Subject: Final Draft Master Plan for Bethesda-Chevy Chase

The Final Draft Master Plan for Bethesda-Chevy Chase prepared by the Montgomery County Planning Board and revised by the County Executive, is approved with the modifications listed below:

**PARCEL  
 C16**

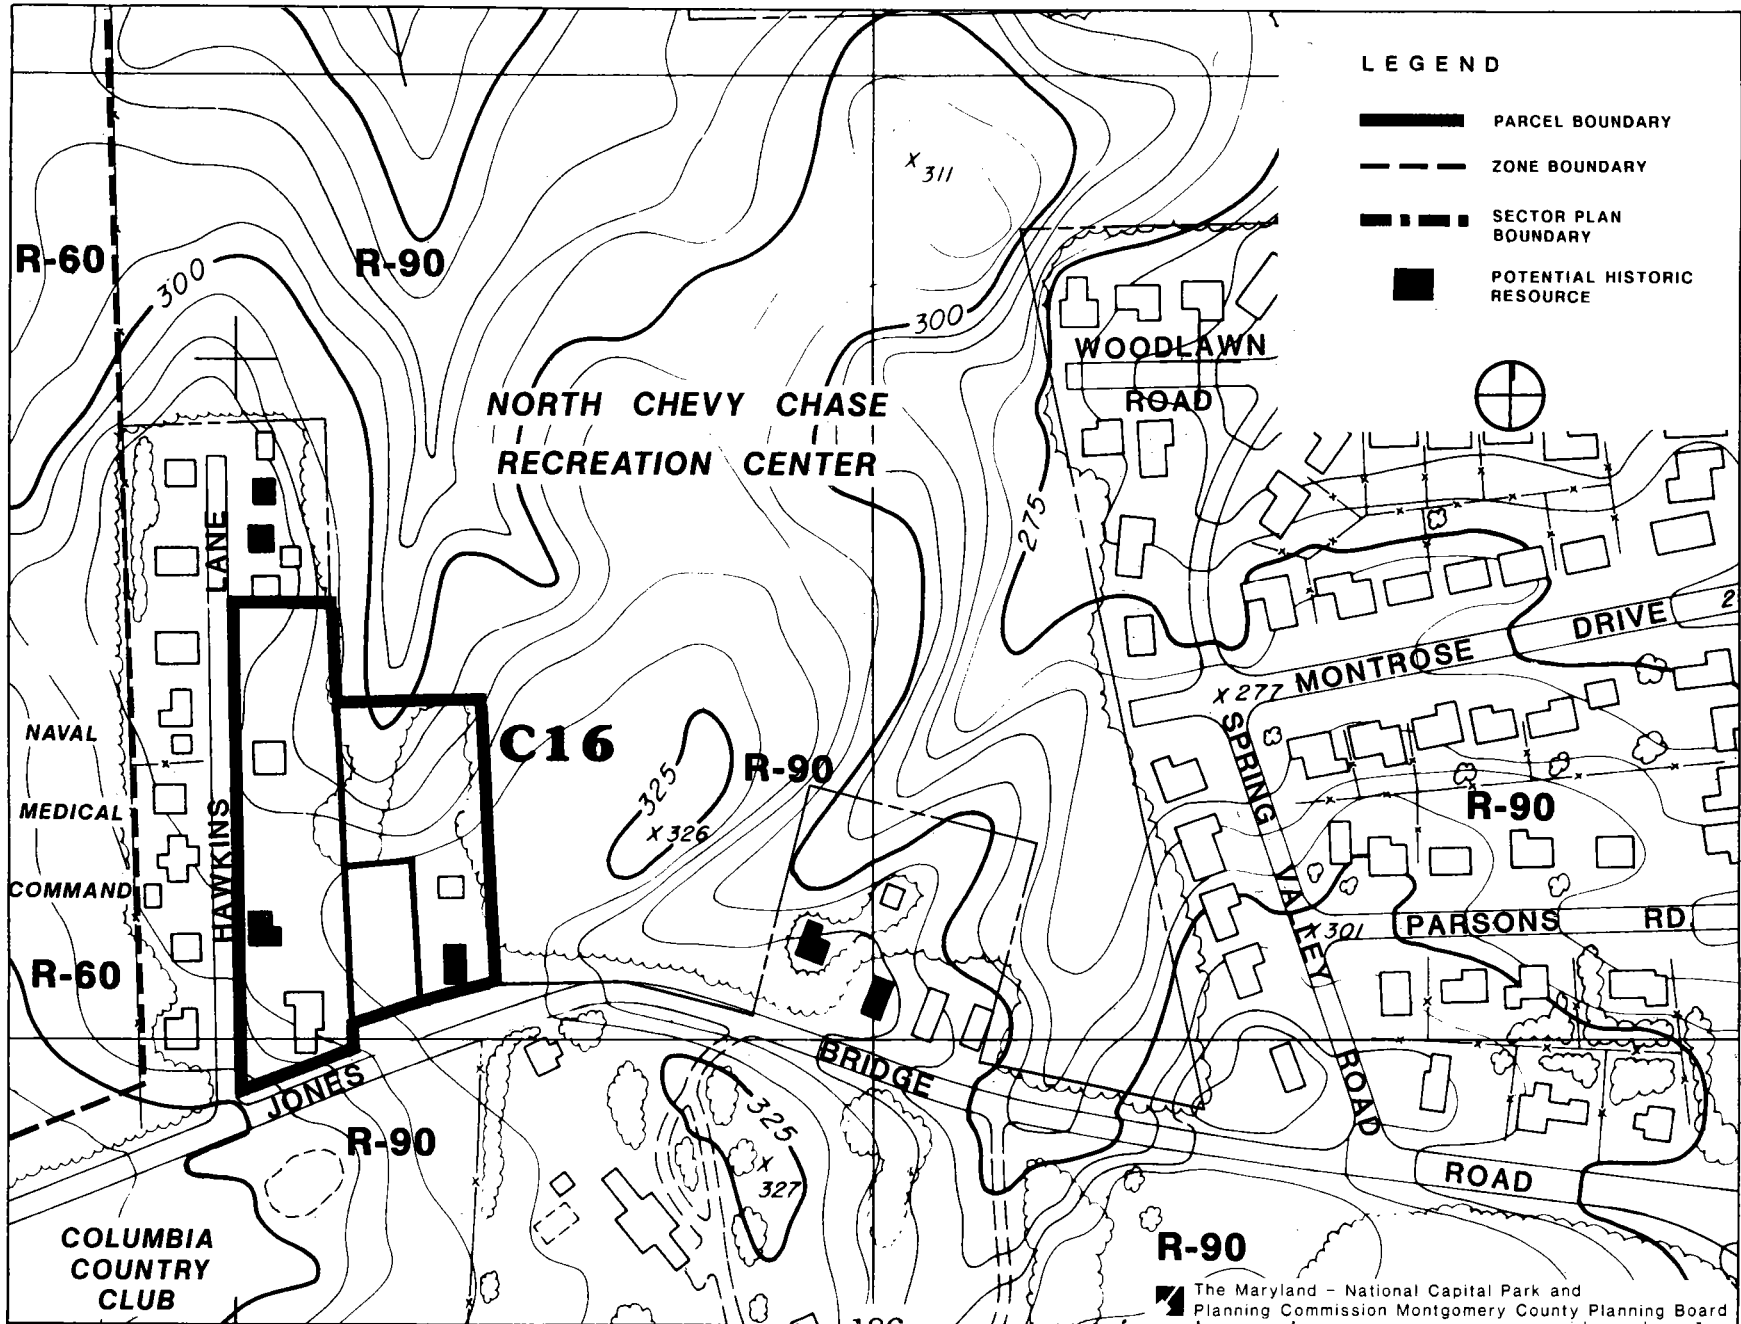
- Page 53 For Parcel C-16, under the column titled "Parcel Identification (#, Location), delete "P863".
- For Parcel C-16, under the column titled "Conditions, Constraints, Comments" change the first bullet as follows:

**C19**

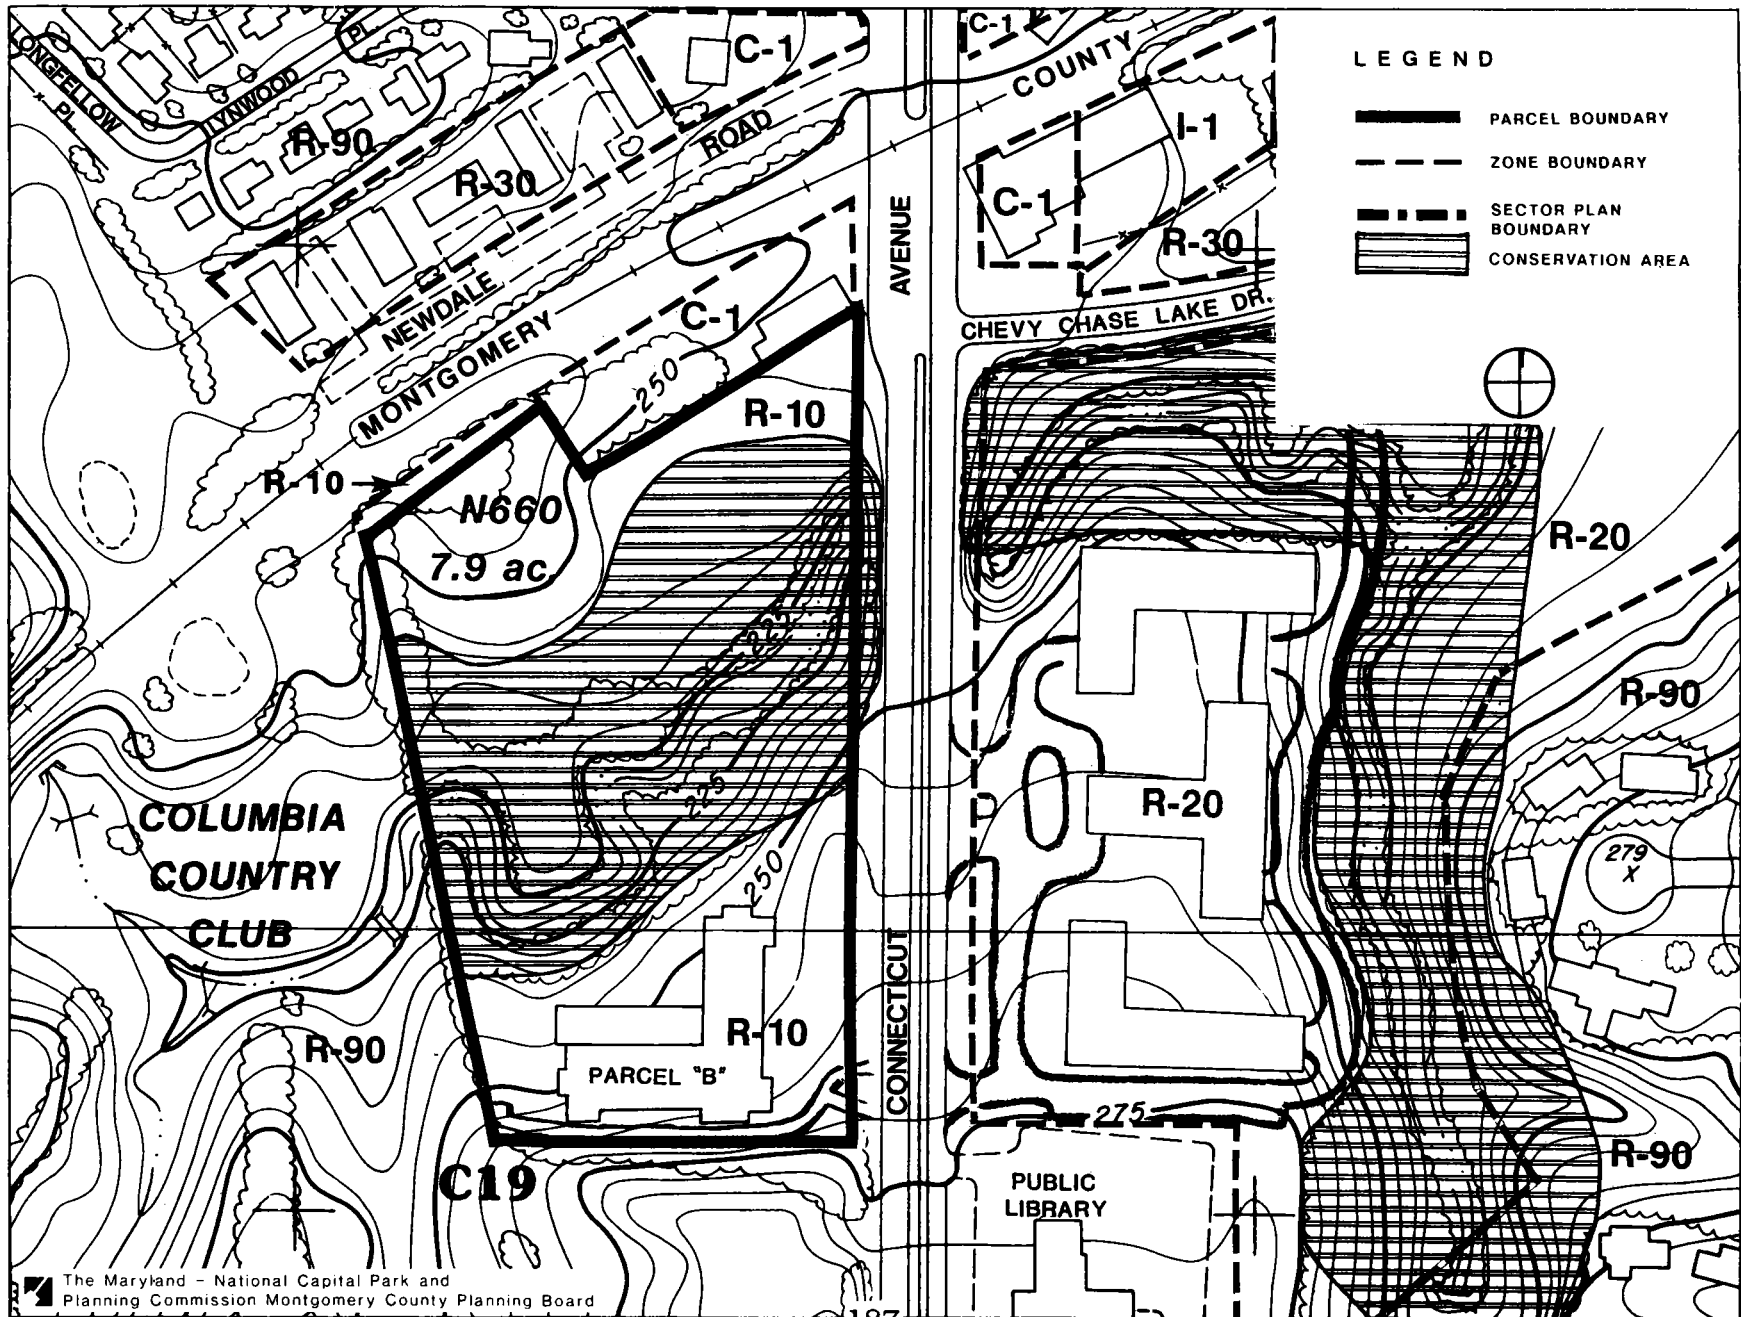
Page 54 For Parcel C-19 under the column titled "Conditions, Constraints, Comments" add back all of the deleted text and move the last bullet to precede all other bullets.

**PARCEL  
 F1**

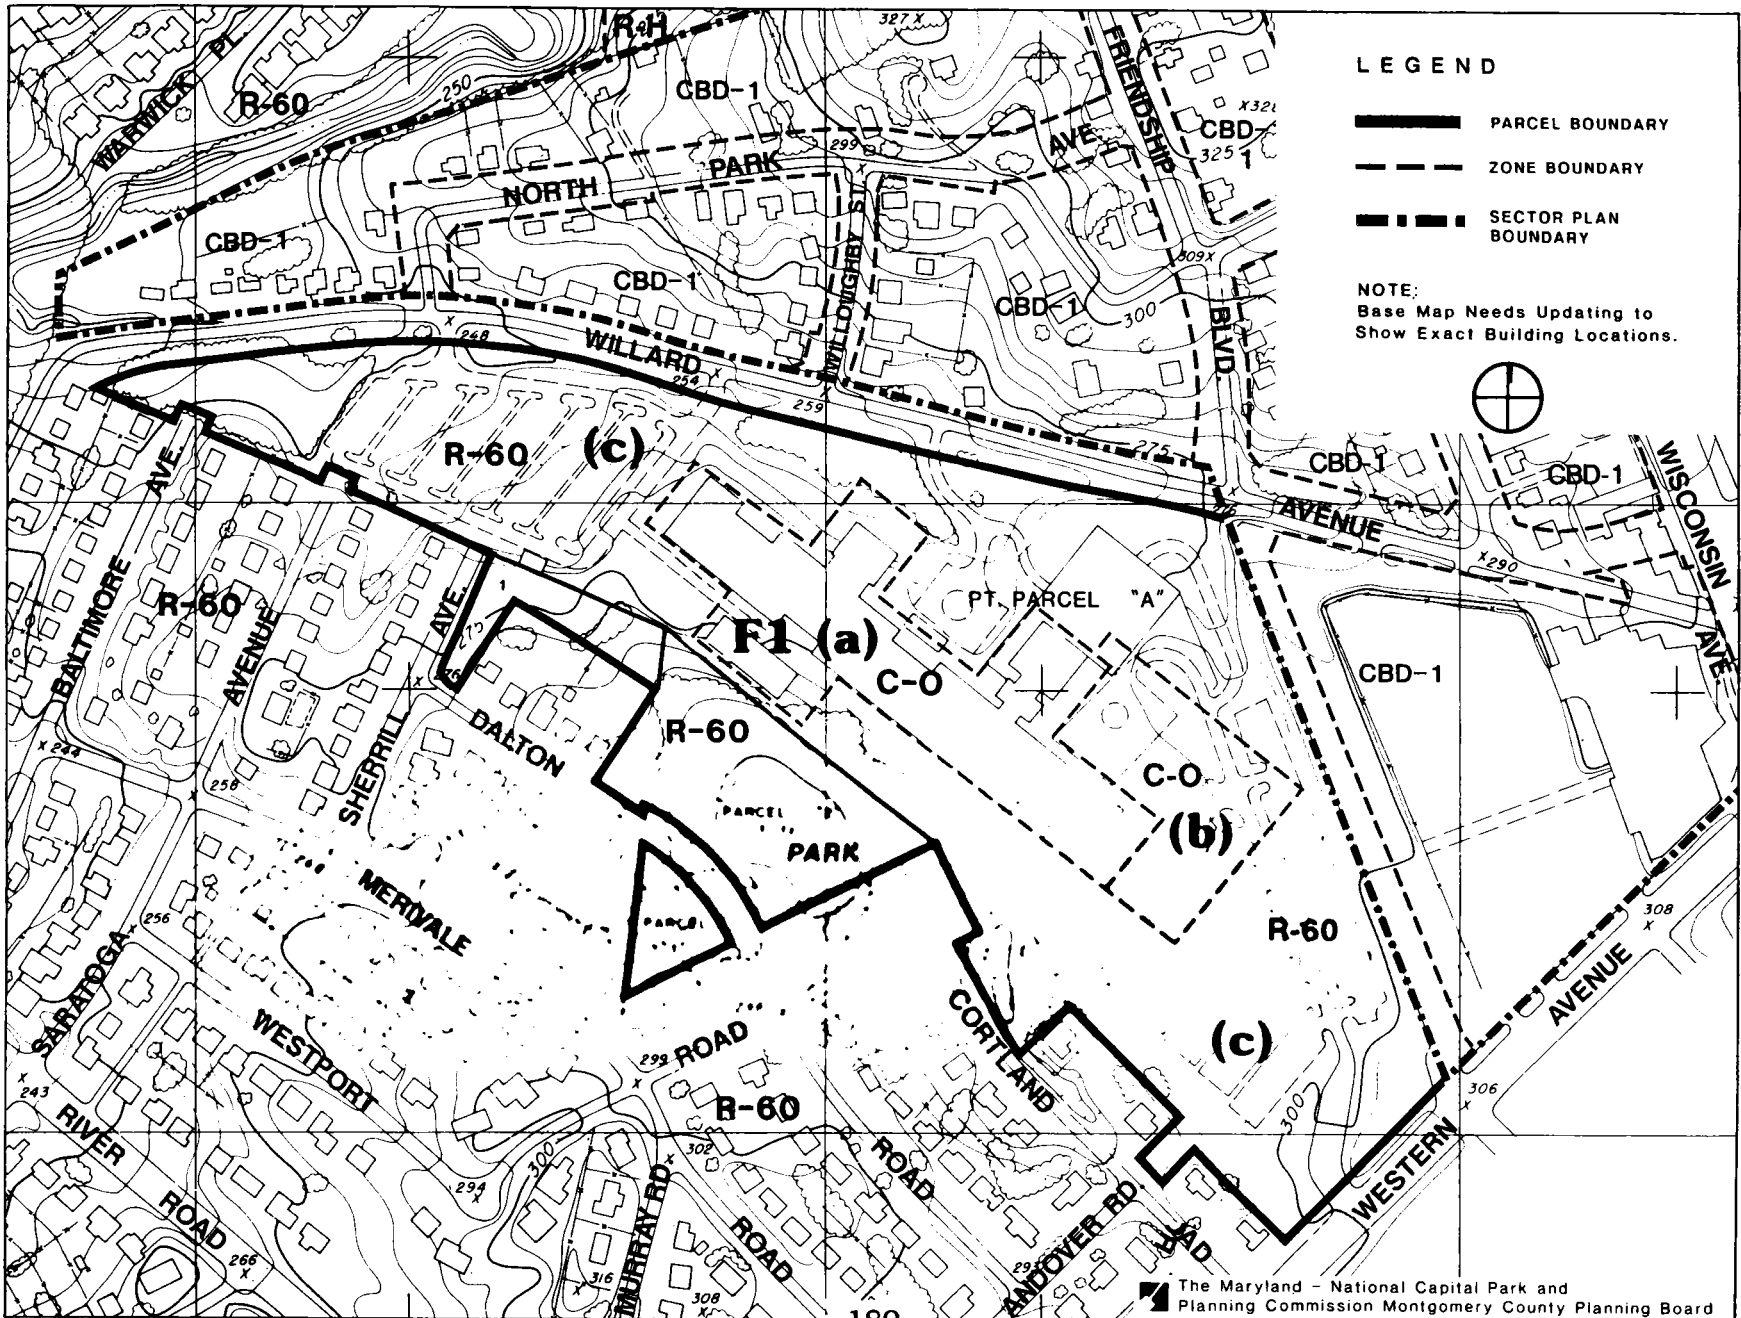
Delete all existing text on Parcel F 1b and replace with the following text for Parcels F 1b and F 1c:

- "- Recommend rezoning of GEICO tract to allow expansion up to 220,000 s.f.
- Endorse land use design, and transportation capacity recommendations.
- Any additional expansion will be considered during the Friendship Heights Sector Plan Amendment."

**P10**

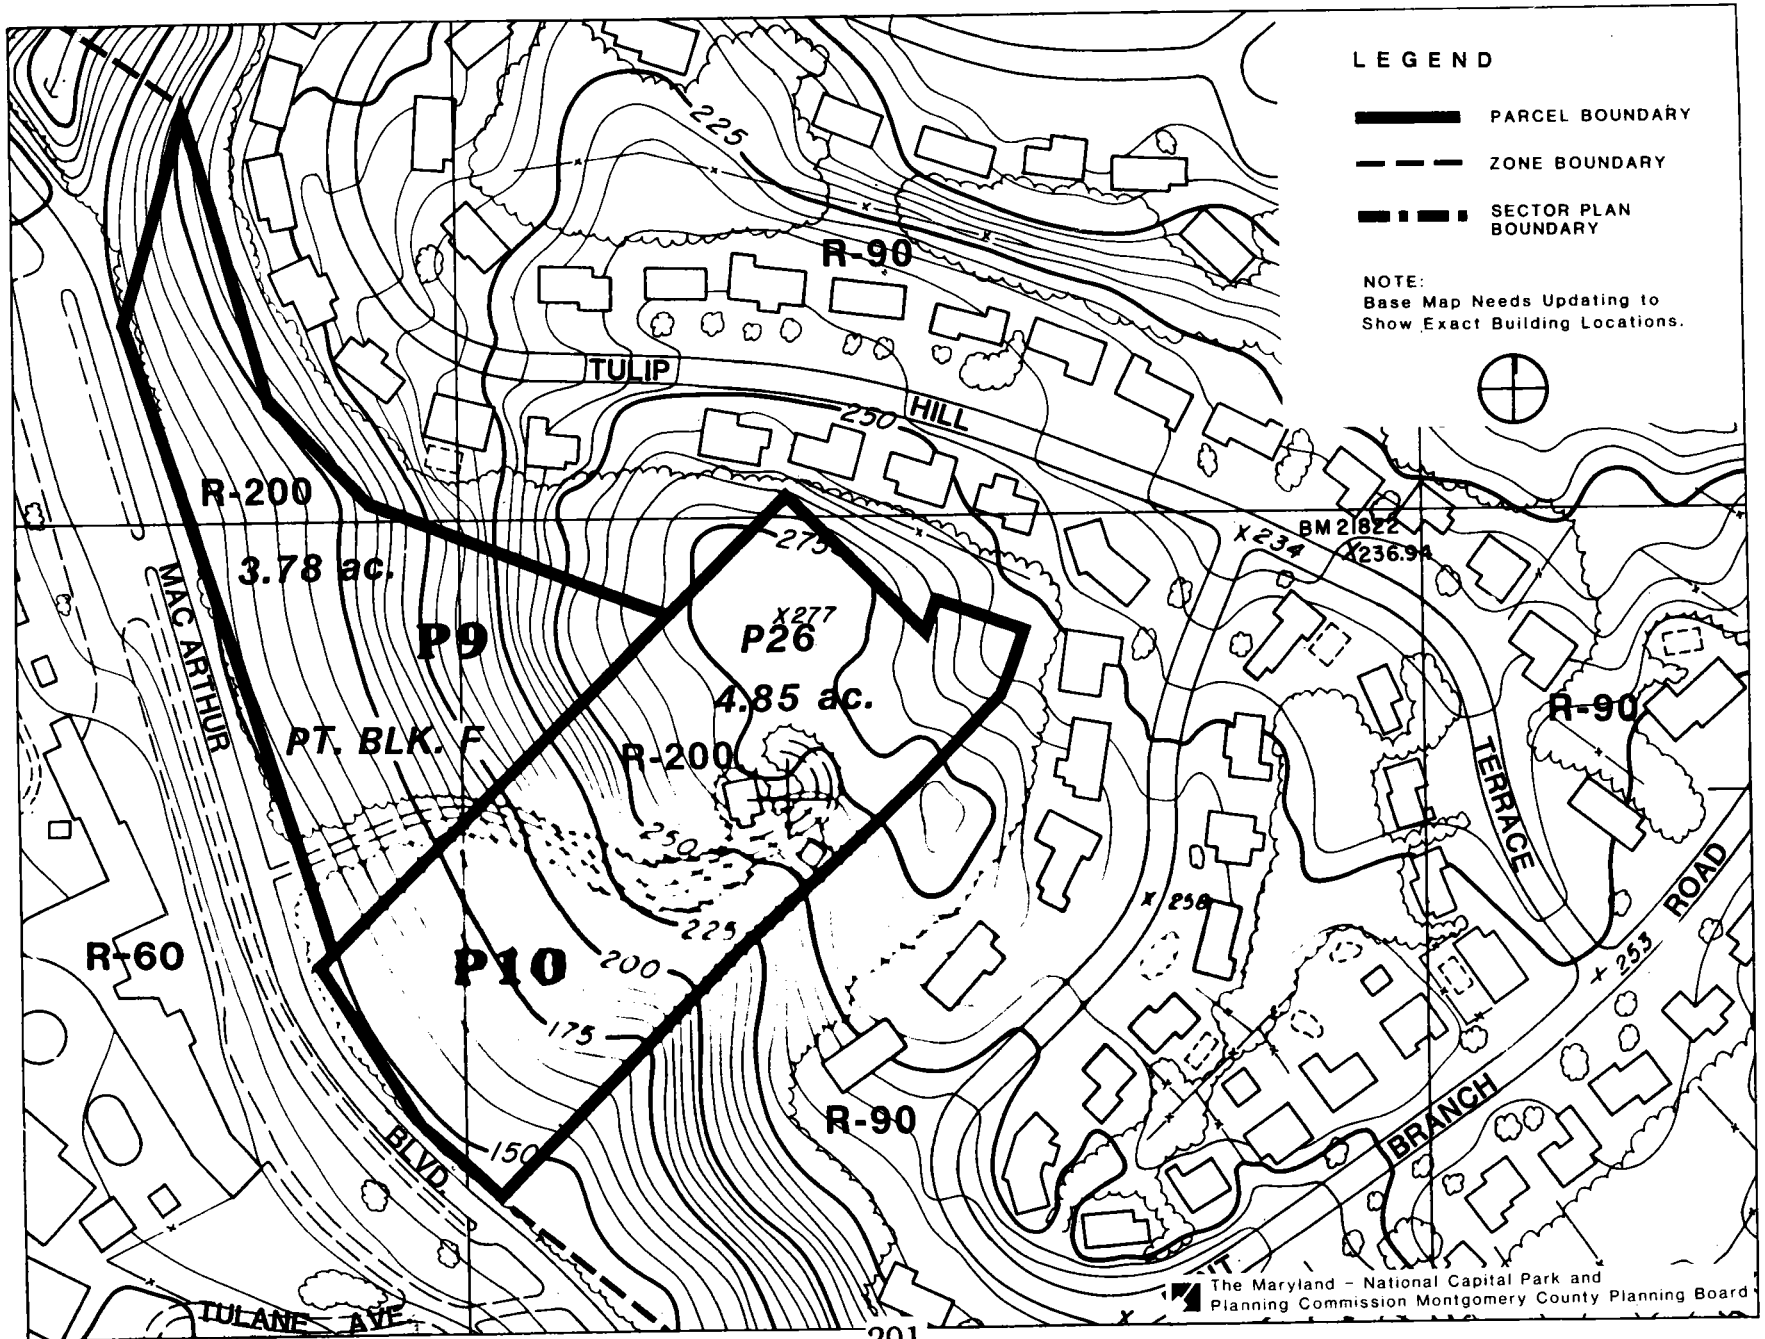
- Page 184 Delete all references to P 10 (Cromwell Drive).
